PZ&B Staff Combination Memorandum: Architectural Commission and Town Council

SUBJECT: ARC-24-015 (ZON-24-025) 153 AUSTRALIAN AVE (COMBO)

MEETING: JULY 24, 2024 ARCOM
AUGUST 15, 2024 TOWN COUNCIL

ARCOM Approved front elevation.

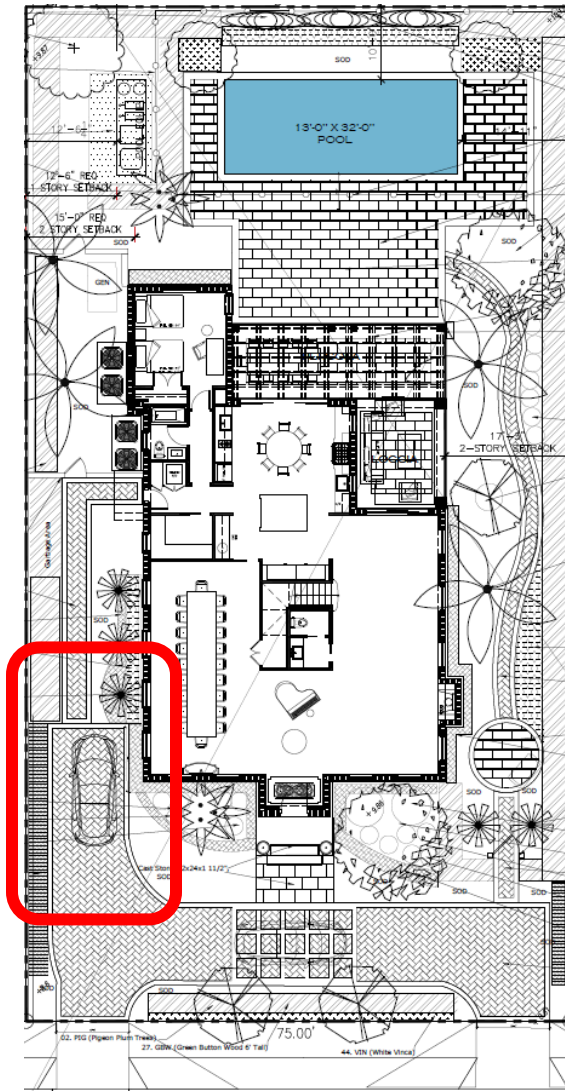
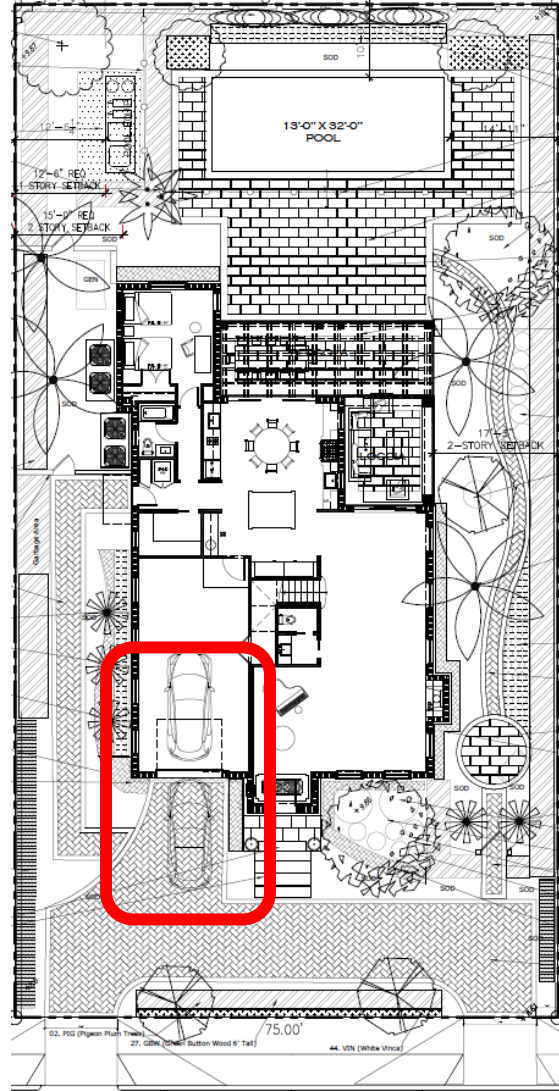
The application is for the construction of a new two-story residence. A preliminary review of the project indicates that the application, as proposed, is inconsistent with the Town zoning code and requires one (1) special exception with site plan review and one (1) variance for the construction of the new single-family residence. The application has been remanded to ARCOM with the instruction to restudy and incorporate a single-garage bay into the project to alleviate the variance request. The applicant has resubmitted plans which now feature a single, street-facing garage bay on the west side of the structure. The hardscape and landscape at the front of the residence has been adjusted according to accommodate the proposed garage. The design was also revised to incorporate a chimney on the east elevation.
